South Texas Project Electric Generating Station 4000 Avenue F – Suite A Bay City, Texas 77414

August 28, 2009  
U7-C-STP-NRC-090123

South Texas Project  
Units 3 and 4  
Docket Nos. 52-012 and 52-013  
Response to Request for Additional Information

COLA Part 2, Tier 2, Figure 1.2-35 will be replaced with the following, more current sectional drawings of the UHS, to be consistent with the text of the COLA.

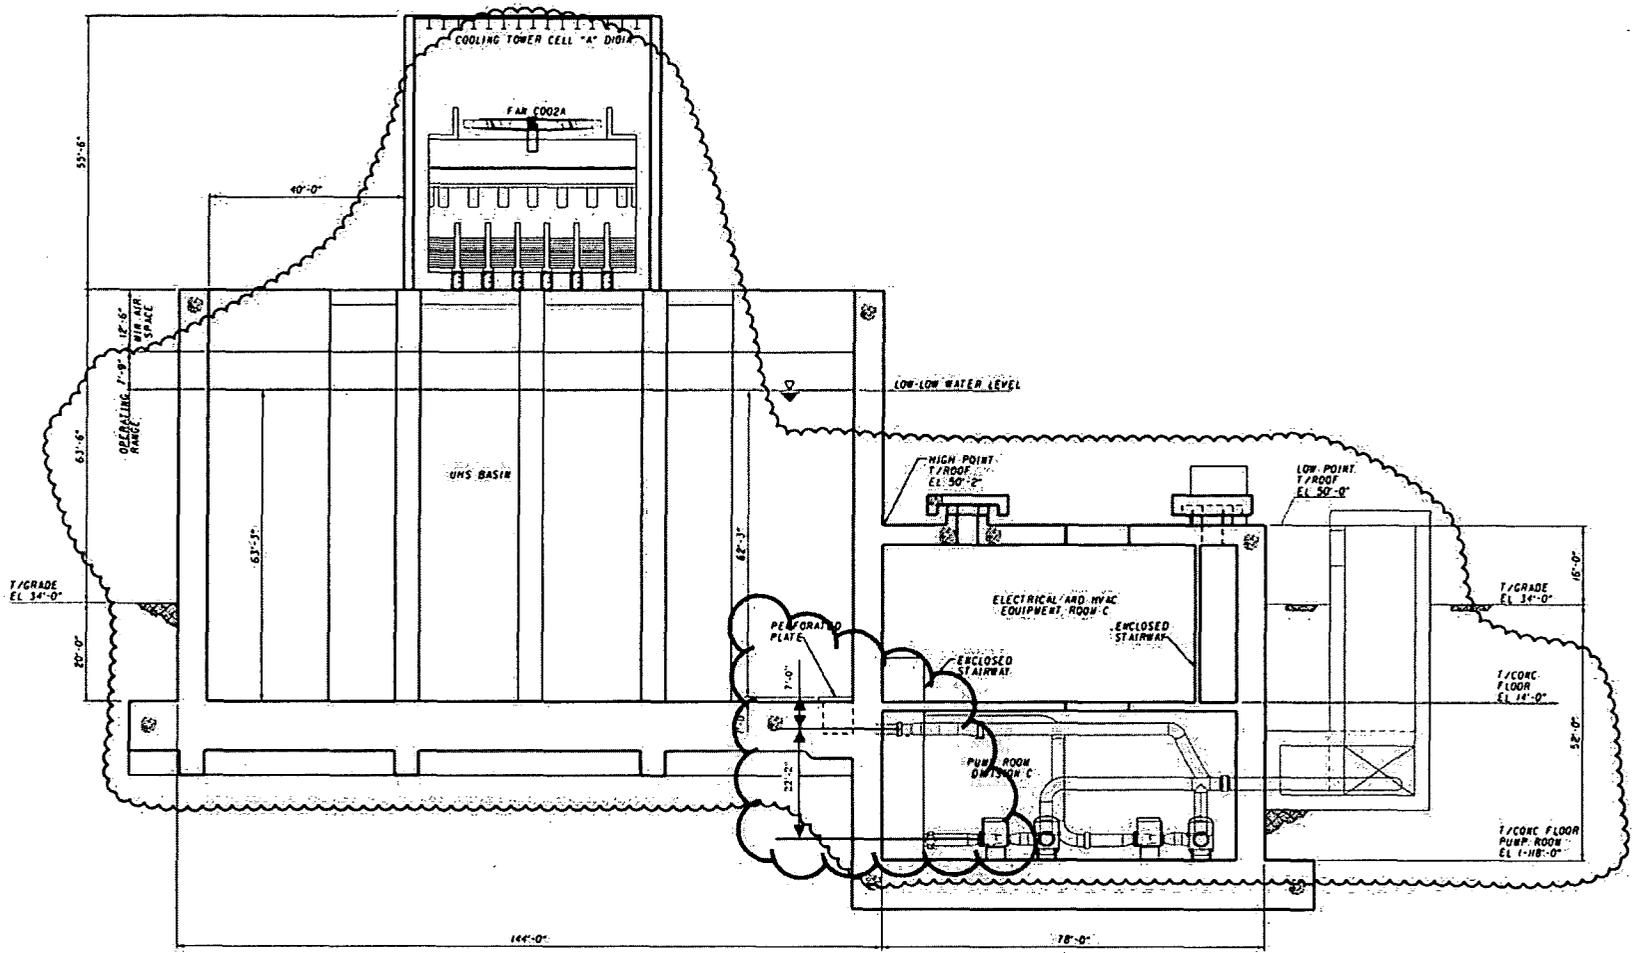
GDC 44 requires reliable operation of the ultimate heat sink (UHS) under all anticipated conditions. ITAAC 3.0-1.2a in Section 9 of the FSAR states that the RSW pump suction will be at 3.35 m above mean sea level (MSL). ITAAC 3.0-1.2a does not specify if the RSW suction elevation is a required minimum or maximum. The NRC staff cannot reconcile this number with Figure 1.2-35 presented in FSAR Section 21 of the COL application where the bottom of the pool is 4.3 m above MSL and the pump is 10 meters below the bottom of the pool (although the electronic copy of the figure is difficult to read). Nor does this elevation agree with Tier 2 Section 9.2.5.5.2(7) which states that the minimum water level is 1.83 m above the suction line's centerline. FSAR, Section 16, SR 3.7.1.2 states that the minimum level in the UHS basin is 0.91 meters with the reference level not provided. The applicant should resolve the discrepancies in the reactor service water pump suction elevation.

ITAAC 3.0-1.2a is referring to the elevation where the pump suction line interfaces with the UHS basin. This elevation is +8 ft (+2.44 m) MSL, which will be specified as a maximum. The UHS basin floor is at elevation +14 ft (+4.27 m) MSL. The RSW pump inlet centerline is nominally at elevation -14 ft 2 in (-4.31 m) MSL. The minimum UHS basin water level elevation, after 30-days of operation without make-up, is +17 ft (+5.18 m) MSL, which is 9 ft (2.74 m) above the pump suction line centerline at the interface with the UHS and 3 ft (0.91m) above the UHS basin floor.
